4th Further Information

**Proposed Temporary Warehouse (Excluding Dangerous Goods Godown) with Ancillary Facilities
for a Period of 3 Years and Associated Filling of Land and Pond in "Agriculture" Zone,
Lot 1434 (Part) in D.D. 107, Kam Tin, Yuen Long, New Territories**

(S.16 Planning Application No. A/YL-KTN/979)

Responses-to-Comments

DRAWING TITLE:
PROPOSED DRAINAGE SYSTEM

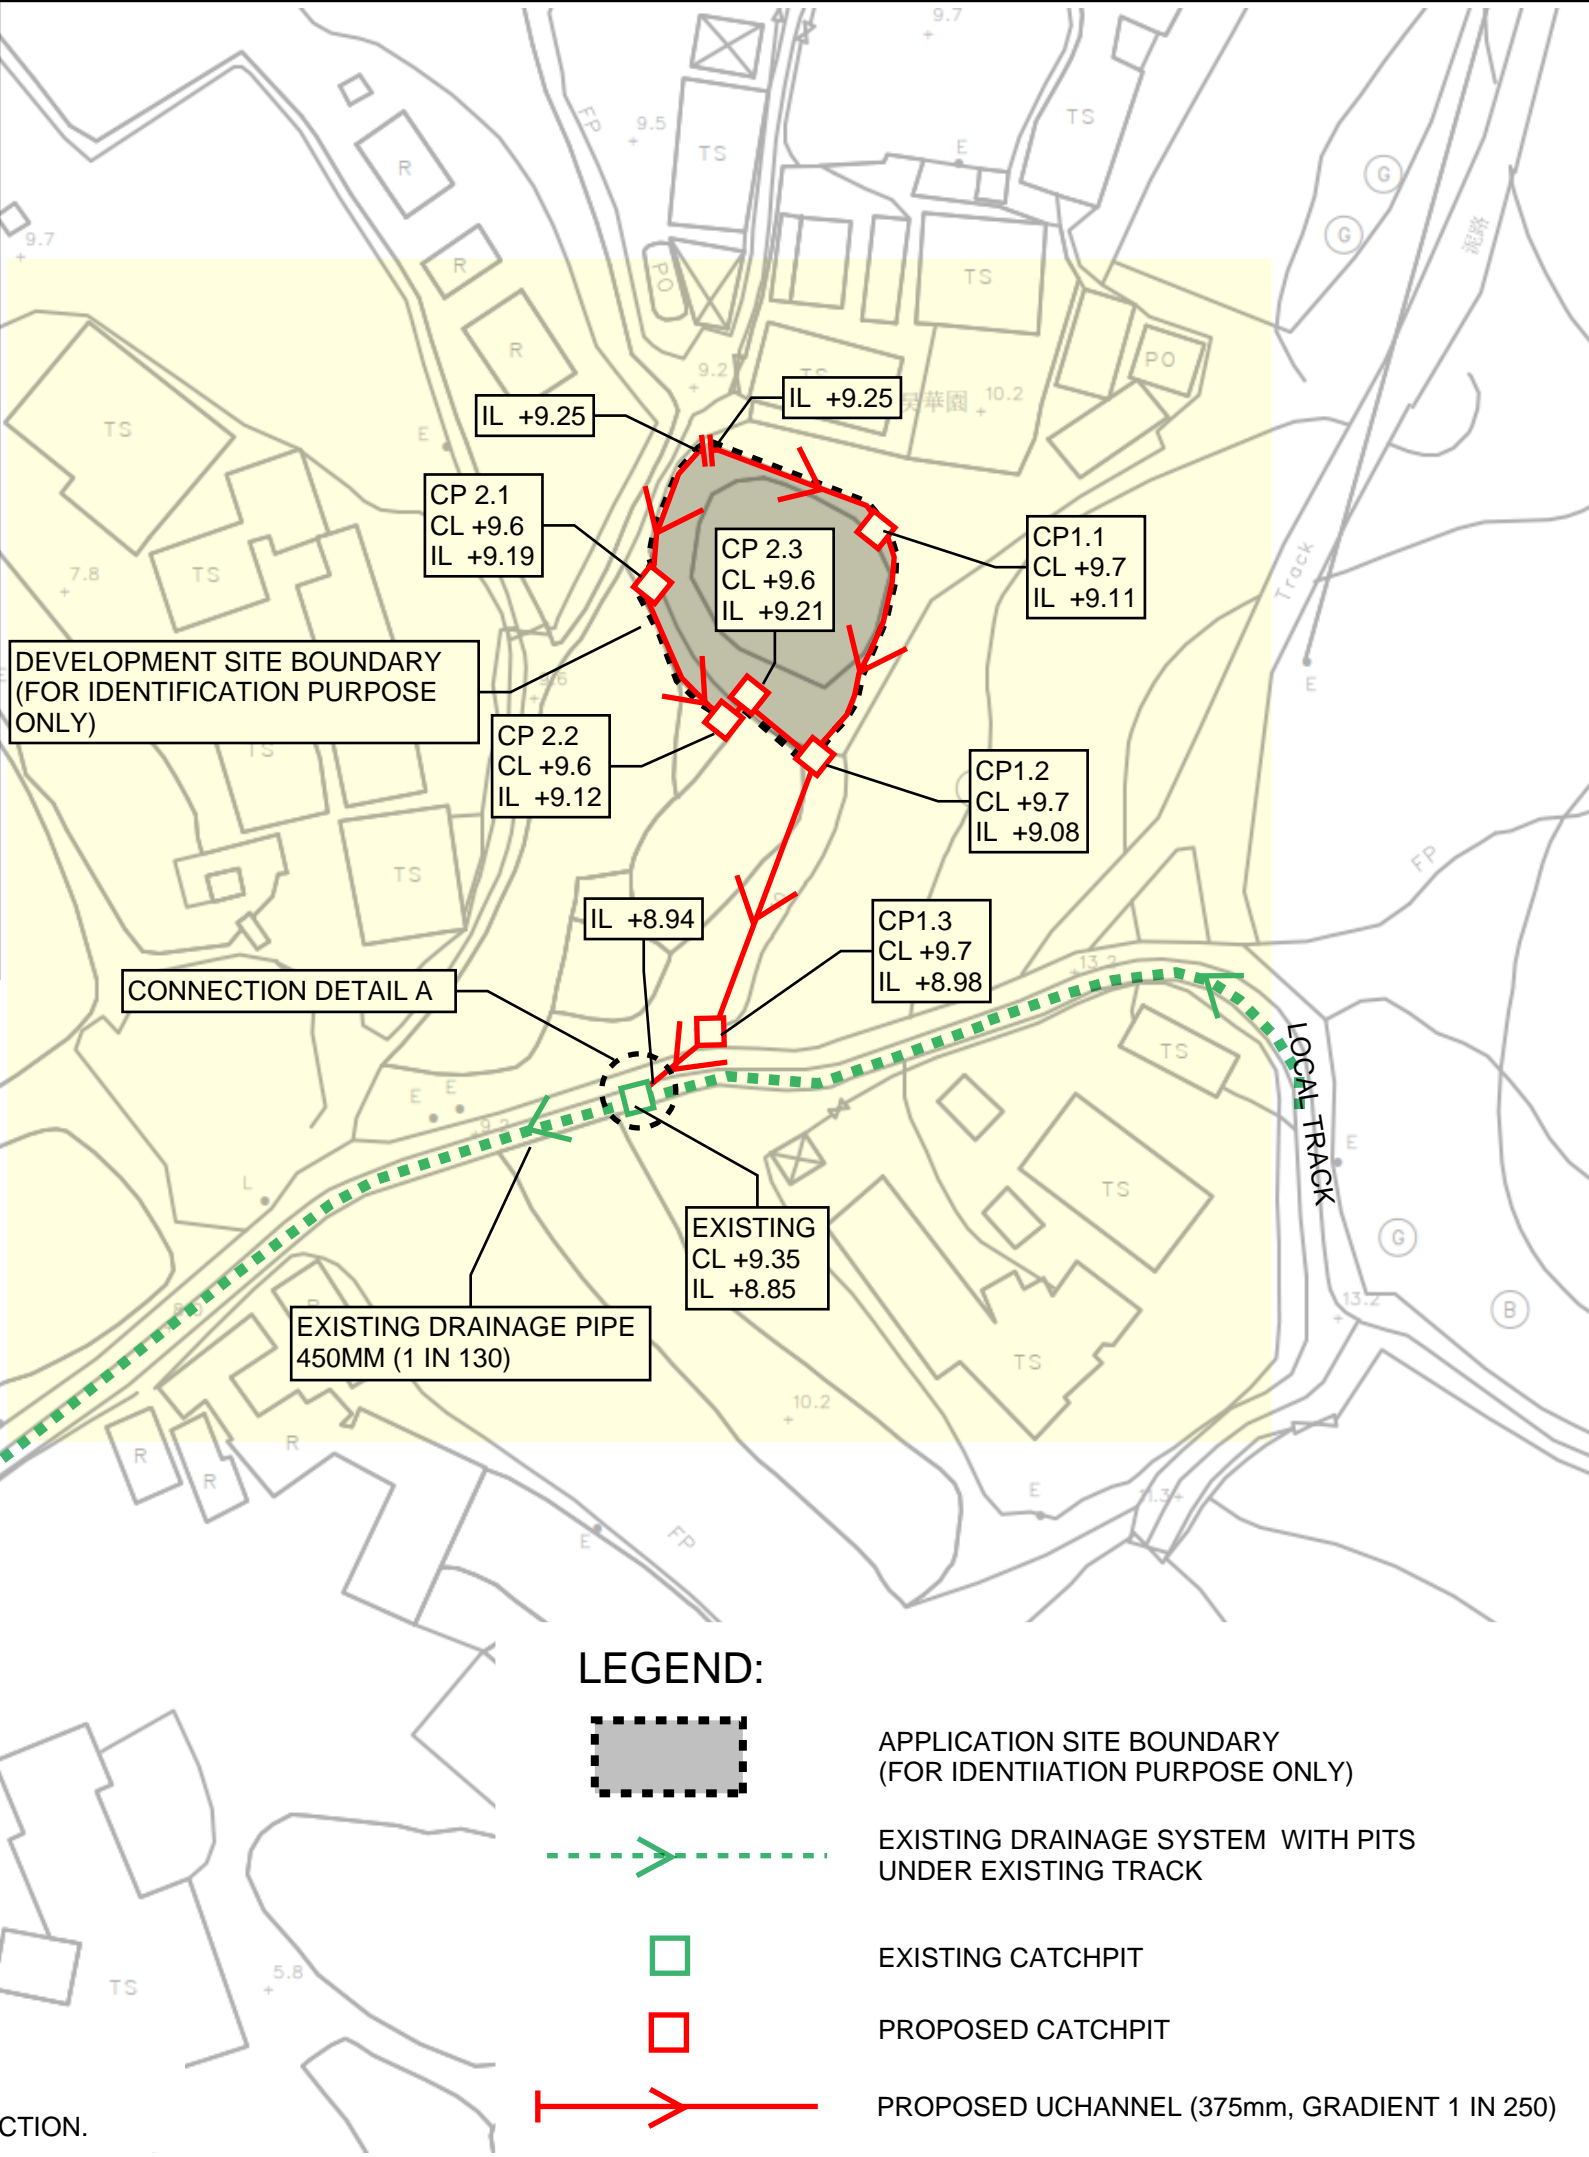
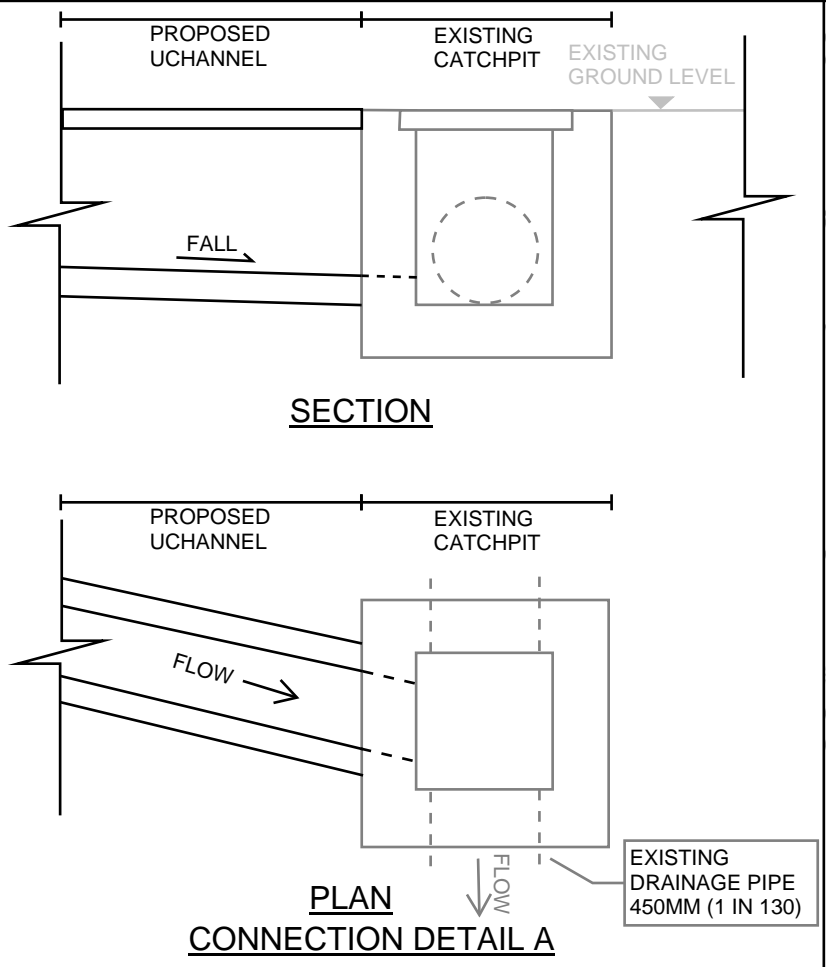
(6)	The details of existing manhole to be connected with are still missing.	Noted. Please refer to the cover and invert level of existing manhole in Figure 3 for your reference. Please note there is no more proposed manhole in the revised proposal as compare to the original proposal.

SECTIONS

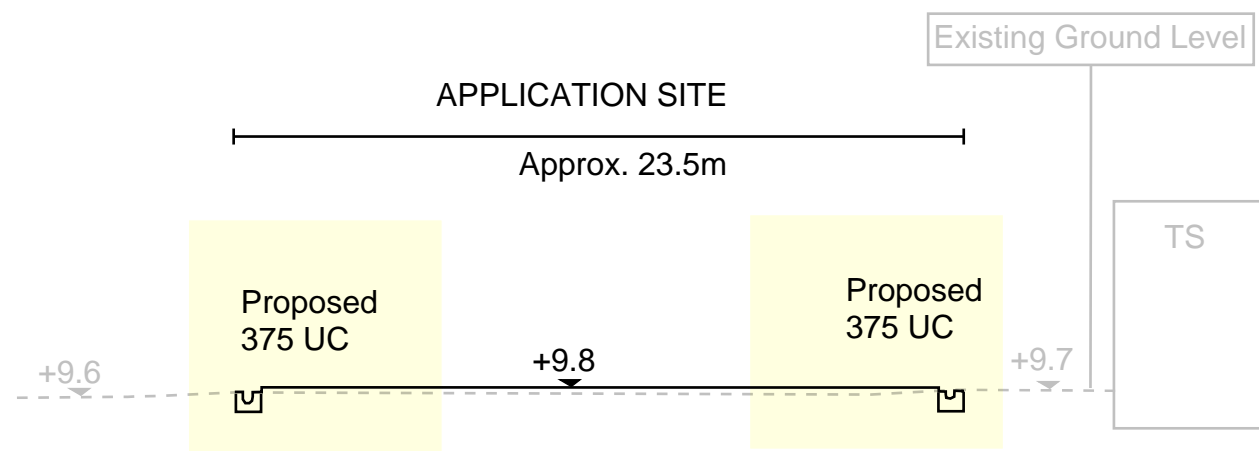
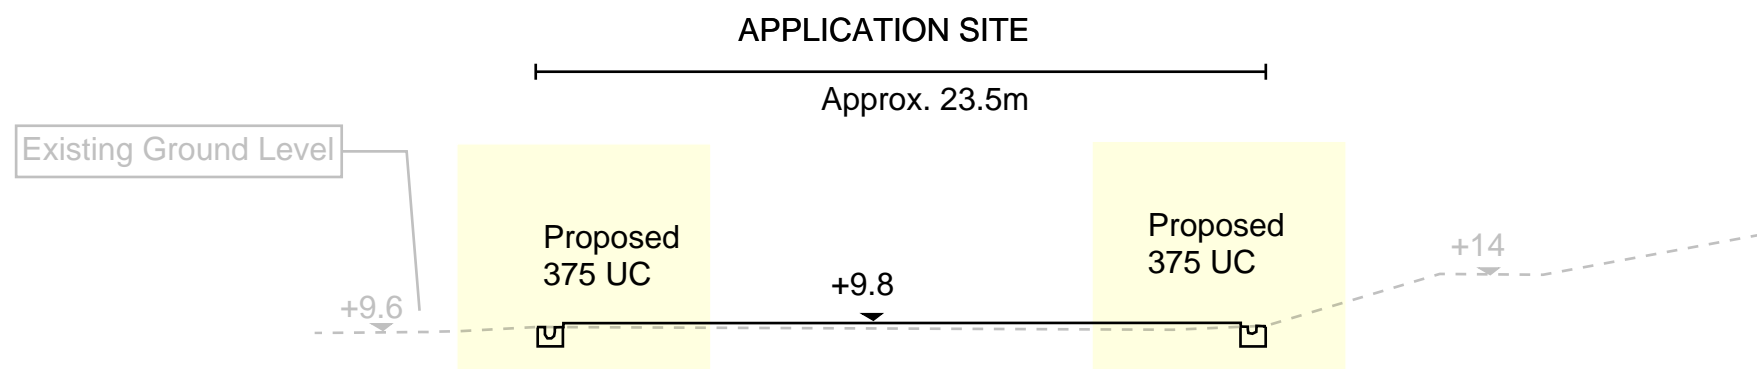
(5)	Cross sections: The proposed u-channels cannot intercept the overland flow from adjacent areas, please review and revise.	Please note the u-channel cover level is updated for intercept of overland flow.
